Revision 1: Author Response to Referee #1, #2, #3

Assessing the feasibility of a directional CRNS-sensor for estimating soil moisture

Till Francke et al.

Geoscientific Instrumentation Methods and Data Systems, Discuss., doi:10.5194/gi-2021-18

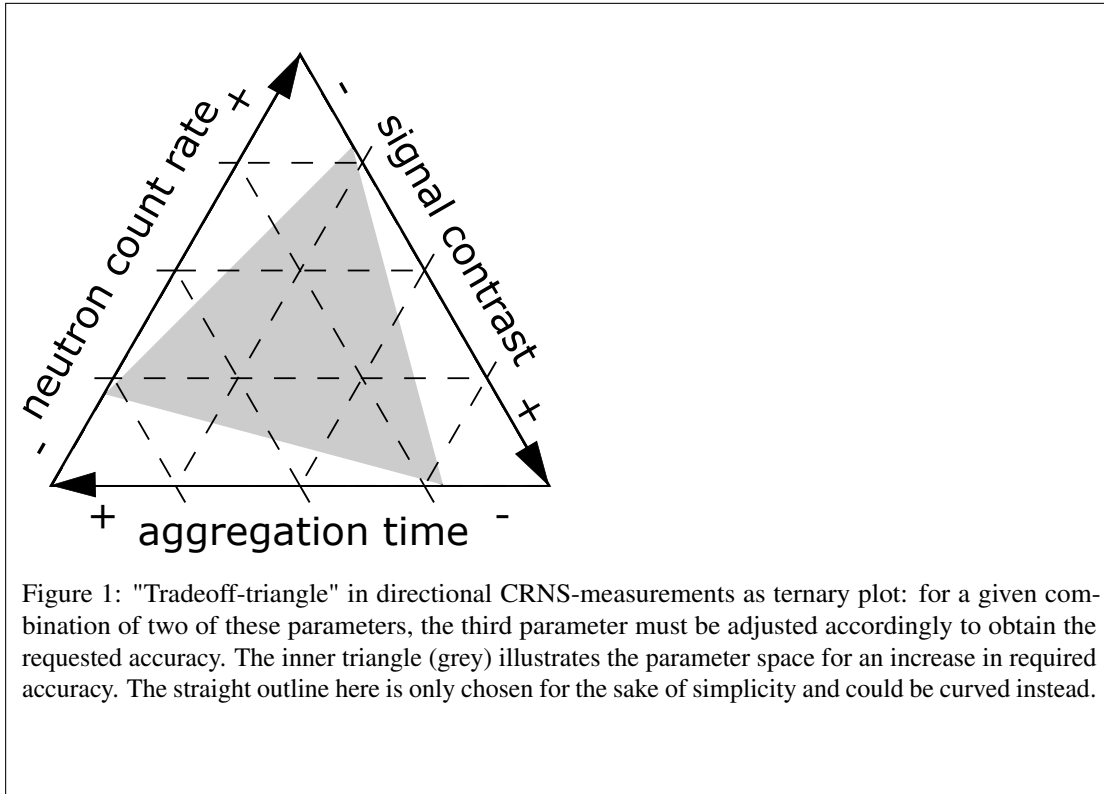
RC: *Figure 2. I like this figure. To make it a bit more explicit it will be good to add in the description the meaning of the shaded area. Are the arrows pointing in the “increasing” direction? Perhaps adding a “+” and “-“ symbols could help the reader. Will it be possible to add magnitudes to the axes and denote with a point the selected combination for this study?*

AR: The shaded areas had no actual meaning apart from being not part of the inner triangle. To avoid this confusion, we have modified the figure, its caption and added "+" and "-".

We intend this figure merely as a conceptual illustration of the trade-off problem. Thus, we'd rather refrain from adding actual numbers. Moreover, the performed multi-dimensional analysis of each of the three factors would result in multiple inner triangles, which would unnecessarily complicate the figure.

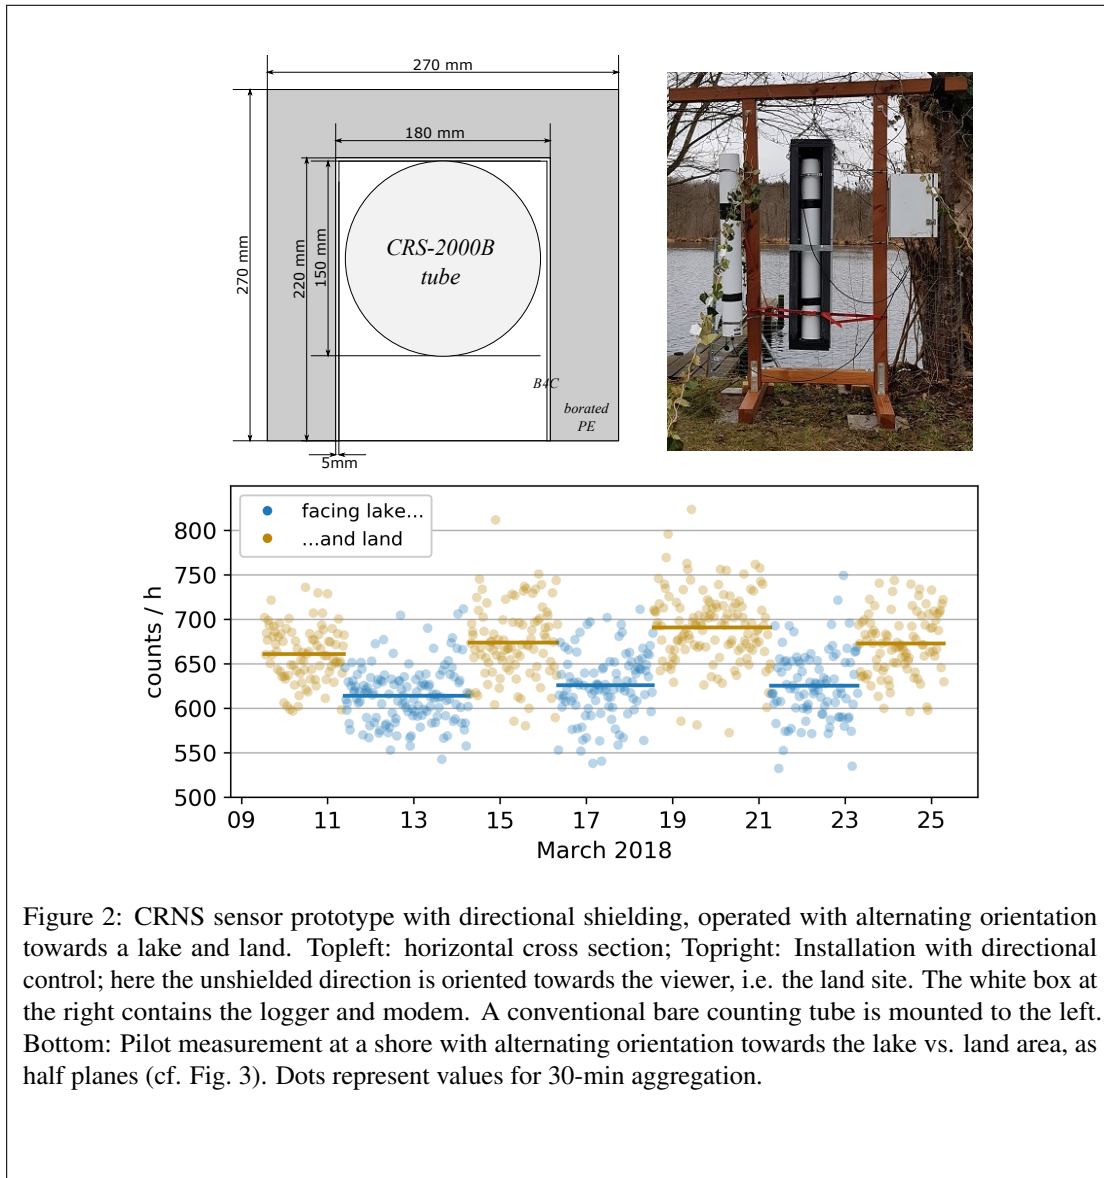
RC: *At the beginning of the manuscript a direction CRNS sensor has been introduced (fig1). Simulations are based on this sensor design. Surprisingly for me, no experimental results has been shown and discussed in the present study. Why that? I believe that some data have been collected since it is stated that this*

prototype has been constructed since 2018 (L69). I think adding experimental results would strengthen the value of this study.

AR: Reviewer 3 is correct assuming that the prototype has been used to collect some data. The first trial merely served as a proof-of-concept at the shore of a lake. No concomitant measurements on the terrestrial site are available for validation. Nevertheless, we have added an illustration of this trial to Figure 1:

In the second trial, the experimental site did not feature half-planes with sufficiently distinct contrast in the hydrogen-inventory and, thus, count rates of the two half-planes. Additionally, the rotating mechanisms did not perform sufficiently stable, resulting in an angular drift of the targeted directions. Not surprisingly,

the corresponding time series thus do not show different count rates for the half-planes. We have added this explanation to the first paragraph of section 3.5:

So far, we have been unable to operate the prototype in a setting with sufficiently high contrast in count rates to practically demonstrate successful discrimination.

Figure 3: Histogram of simulated neutron origin angles for a hypothetical ideally-shielded detector registering only neutrons with incidence angles between 90 and 270 degrees.

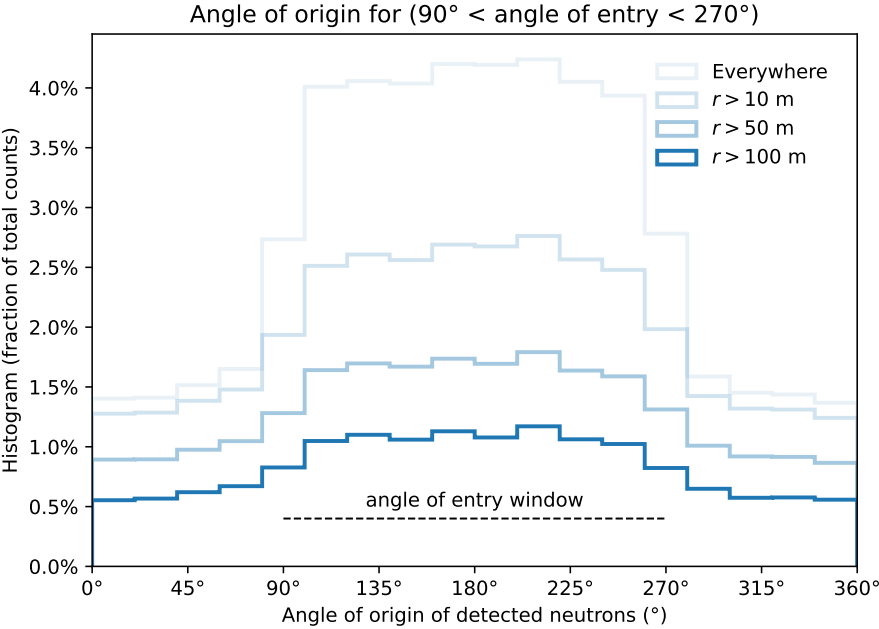
RC: *The final result seems to be that scanning CRNS is hardly feasible and only strong soil moisture changes and patches could be detected with long integration time. Despite I believe that scientific papers should also present and discuss “what does not work” to provide guidelines for further studies, I usually expect that from lab-field studies where it is hardly possible to repeat or to increase the numbers of experiments. In contrast, all the results of the present study are based on simulations. The Authors well discuss some limitations on the numerical settings and they often acknowledge that further simulations could shed lights on how to design an effecting settings (e.g., L411, L428, L438). The Authors conclude for instance that progress in detector technology and optimizing the shielding towards wider FOVs but more specificity could alleviate some of the restrictions and make directional scanning a useful tool for tailored use of CRNS (L501-502). I believe that the scientific value of the present study should be improved not speculating on that. Instead few specific additional simulations could support the design of a proper scanning CRNS in the future. Specifically, I personally suggest to consider a hypothetical very high sensitive sensor with a cone-shaped shielding (smaller angles) that has been shown in literature to be able to discriminate directional neutron fluxes but not in the context of soil moisture observations (see Becchetti et al, 2015). Alternative (or additional) settings based on the experiences of the Authors could be also considered. Despite I agree (see your comments at L442) that these set-ups could be not very practical nowadays considering among others the need of high sensitive (and probably expensive) sensors, it could be probably feasible in the near future considering current sensors developments. At such, the present study would provide a strong bases for further sensor development. At the present status, this is not the case.*

AR: Without doubt, it would be of high use to gain precise indications on promising new sensor developments (or, more precisely, the design of directional shielding). However, we would like to point out that the focus of our study is presenting a) an easy-to-build example of a directional shielding that can be rotated, b) specific computationally-expensive numerical simulations of this prototype and c) an analytical method to generalize the simulations to a wider range of settings to assess the general feasibility of directional CRNS.

We do not claim to exhaustively explore other designs for shieldings, which would require tremendously more neutron simulations and fundamental decisions on what can still be considered feasible, e.g. in terms of automatic rotation. However, regardless of the shielding design, the fundamental problem persists: The non-geometric transport of neutrons, which dominates over larger distances, poses fundamental restrictions on any directional neutron measurements in natural settings. This has been demonstrated with the "favourable" detector, showing that even with perfectly impermeable shielding material, directional specificity as expressed by directional contribution η , will not exceed 0.72 (see Table 5). To make this clear, we have added the following sentence to the conclusions:

This fundamental limitation is inherent to measuring neutrons under environmental conditions and cannot be alleviated by detector design and influenced only marginally by design of the shielding.

This image illustrates the directional sensitivity of a perfect 180° shielding ($FOV_{shielding} = FOV_{targeted} = 180^\circ$). As with the simulated prototype, the directional specificity decreases with distance. This again underlines that the main limitation lies in the non-geometric transport of the neutrons over longer distances – a characteristic that cannot be influenced by the shielding. For this hypothetical "ideal" shield, the directional contribution is $\eta \approx 0.725$. Likewise, this value cannot be exceeded by any shield blocking 180°. However, higher values might, at least theoretically, be obtained when the "constructional FOV ($FOV_{shielding}$) is further narrowed, while keeping the area of interest ($FOV_{targeted}$) constant. As this comes at the cost of a reduction in total counts, it again would require an extensive analysis to find an optimal balance between η and count rate such that the signal of the different viewing angles can be statistically distinguished and determined.
